# First Solar FS Series Module Clip Compatibility

## Compatibility of Jurchen Technology TP-MK-A 80 with FS Series Modules

Figure 1: Jurchen TP-MK-A 80 - X M / Middle Clamp

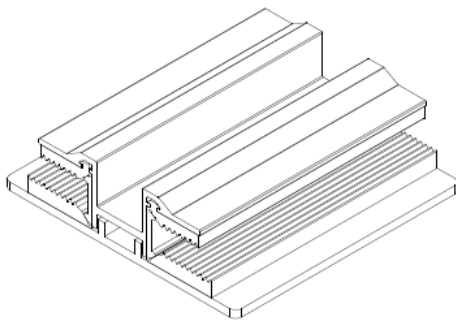
The Jurchen Technology TP-MK-A 80 in conjunction with FS Series module laminates has successfully met the First Solar mechanical load test. The proposed mounting clip design in conjunction with FS Series module laminates also meets the technical requirements concerning clip design that are specified in document PD-5-320 (see Figure 1 and Figure 2 below).

Therefore, the Jurchen Technology TP-MK-A 80 in conjunction with FS Series module laminates is approved for use as long as the mounting system complies with First Solar's technical and mechanical requirements for mounting systems, as described in document PD-5-320.
